N00164.AR.001138
NSWC CRANE
5090.3a

Subject: **Final**
Navy Response to United States Environmental Protection Agency (USEPA) Comments
(Received Electronically: December 21, 2006) Regarding Solid Waste Management Unit
(SWMU) 3 (Ammunitions Burning Grounds) Corrective Measures Proposal (CMP)
Naval Surface Warfare Center (NSWC) Crane
Crane, Indiana

**UNITED STATES ENVIRONMENTAL PROTECTION AGENCY (EPA) COMMENTS
(DATED DECEMBER 21, 2006) ON
DRAFT CORRECTIVE MEASURES PROPOSAL (CMP) FOR
AMMUNITION BURNING GROUNDS (SWMU 3)
DATED JULY 2006
NAVAL SURFACE WARFARE CENTER (NSWC) CRANE
CRANE, INDIANA**

FIGURE 1-3

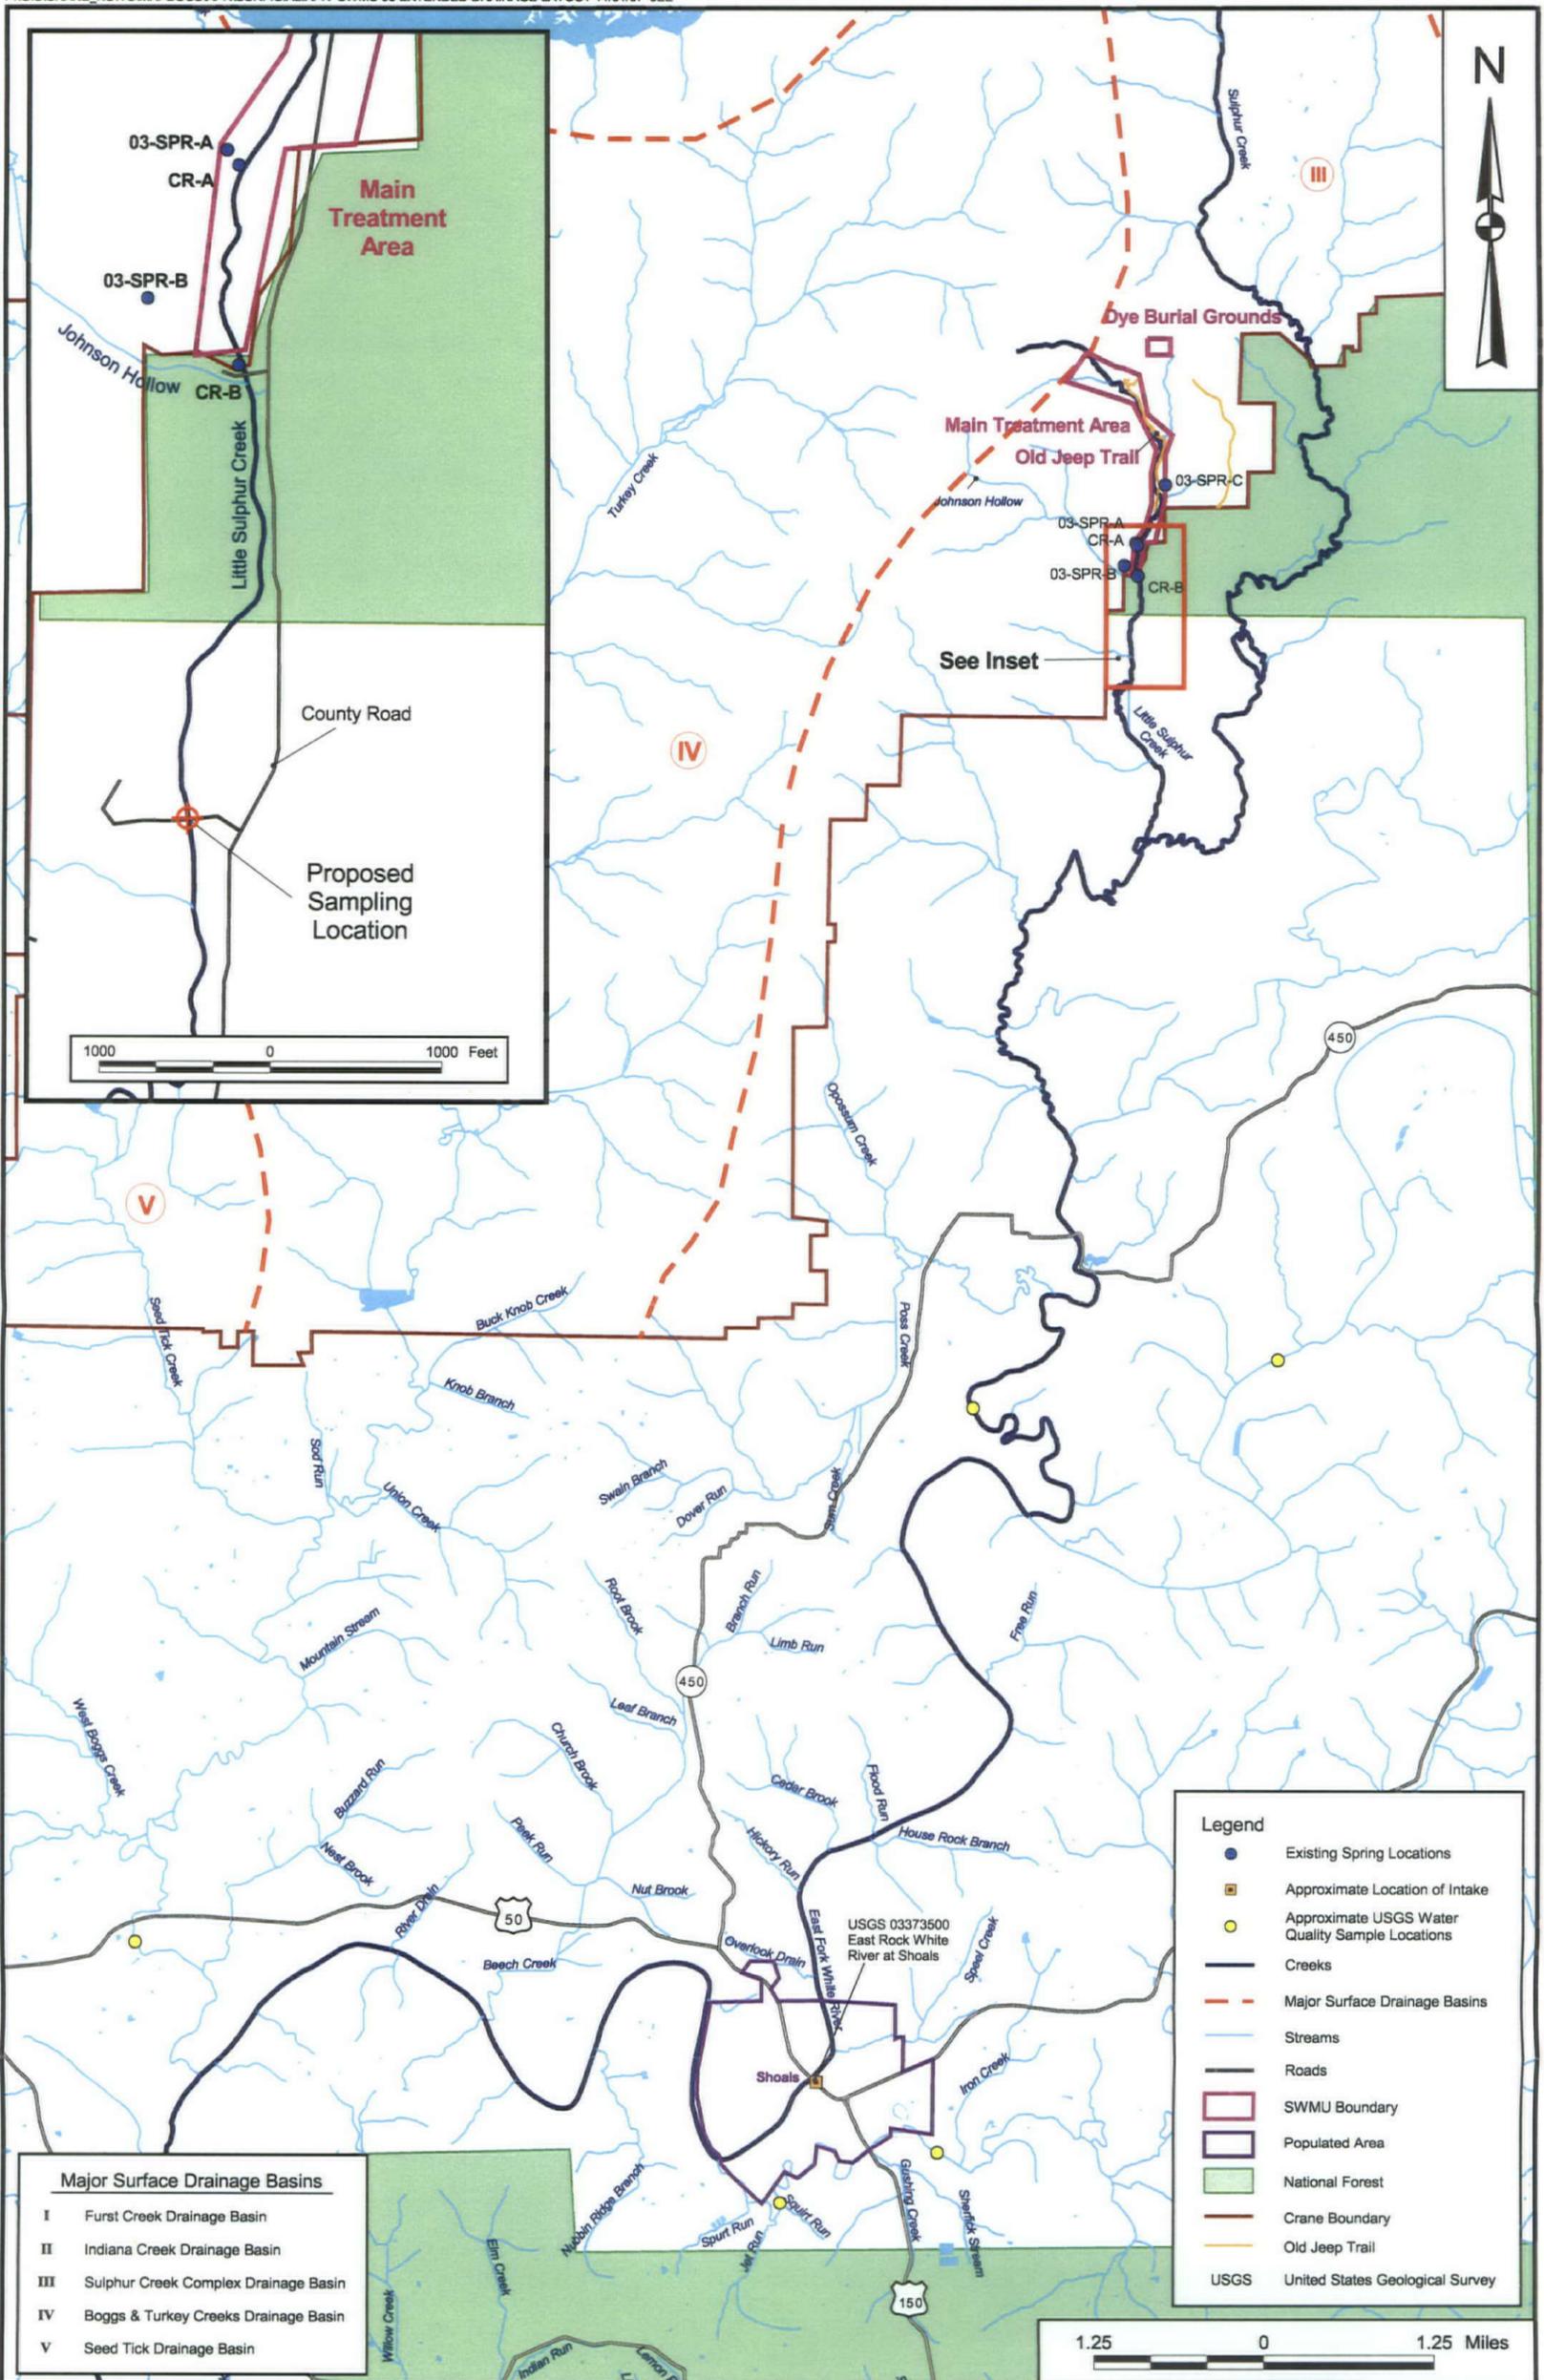
Comment EPA-5: Modify Figure 1-3 to note the Johnson Hollow tributary.

Response EPA-5: Figure 1-3 (Attachment 2) has been modified and the Johnson Hollow tributary is now labeled.
